Further development of chest deflection proposals

Prepared by Jolyon Carroll
Senior Researcher

UN Informal Group on CRS 24th Nov 2014

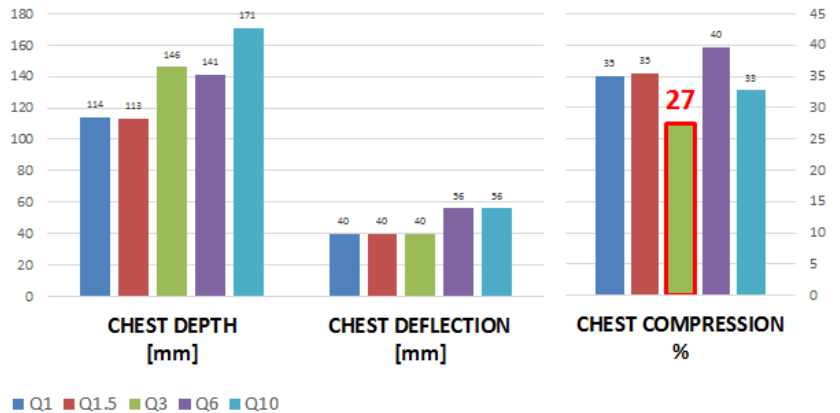
- Limited biomechanical basis
 - Chest & abdomen injury criteria task force yet to report
- Q6 threshold exceeds measurement capacity of dummy
 - No CRS could fail test with this dummy
- Large step between Q3 and Q6 not justified by human geometry

Chest Deflection

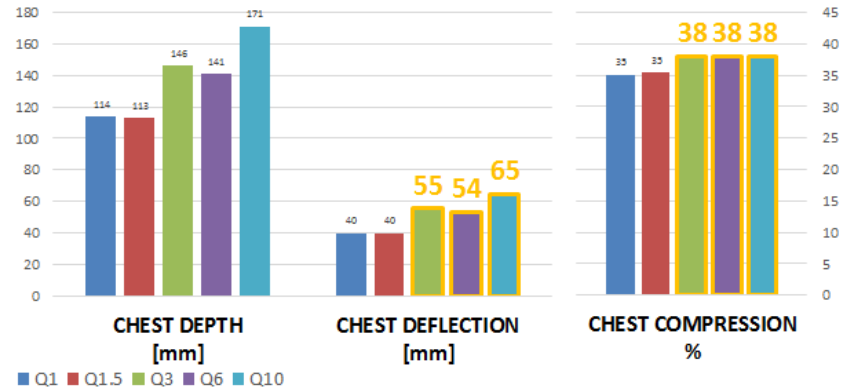
- Analysis based on dummy not human chest depth
- Cybex proposal exceeds measurement capacity of Q3 and Q10(?)

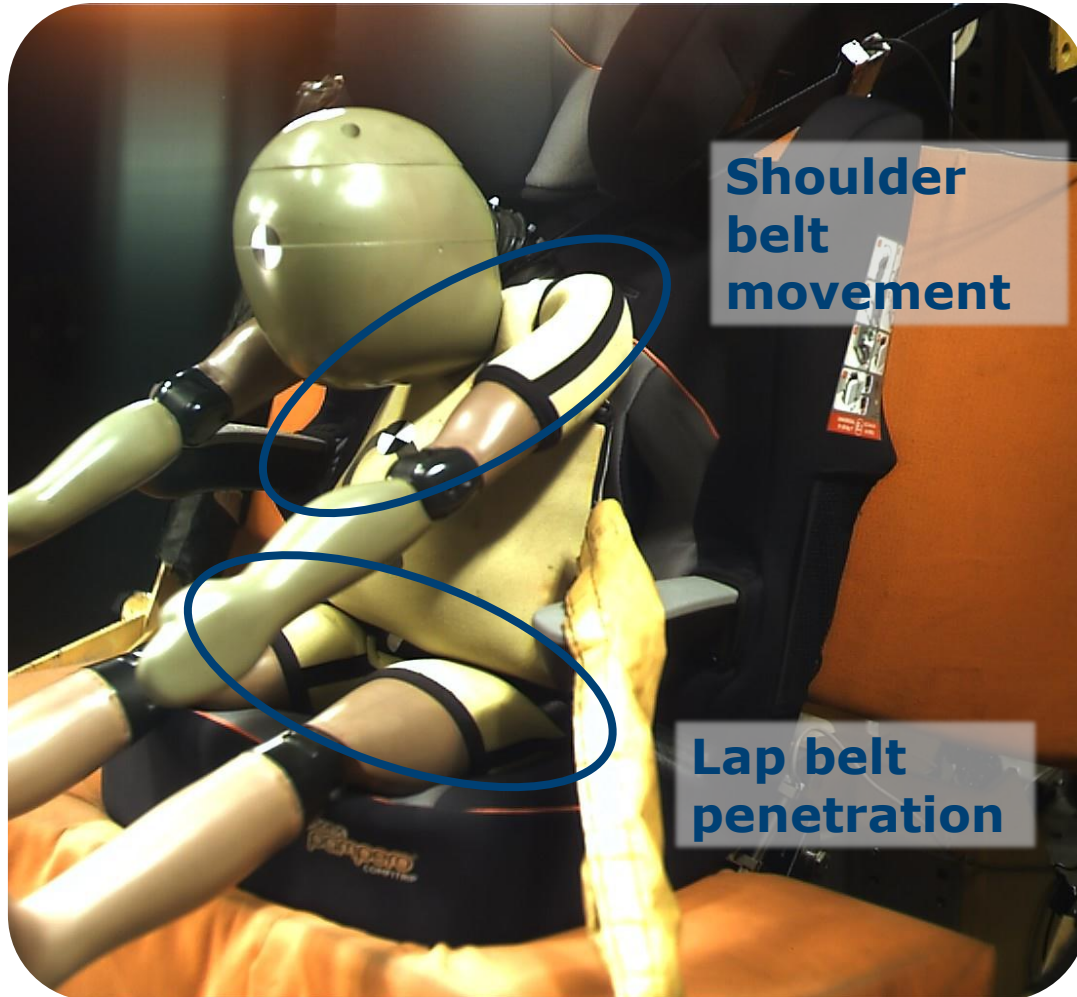
Robust thresholds are important, but we can't forget dummy / belt interaction issues and their effects on sensor measurement (see CRS-42-07e)

Diagonal belt loads dummy away from deflection sensor – limit belt movement or 2nd sensor needed?

Lap belt unlikely to load abdomen in boosters (even with no CRS) – new set-up conditions?
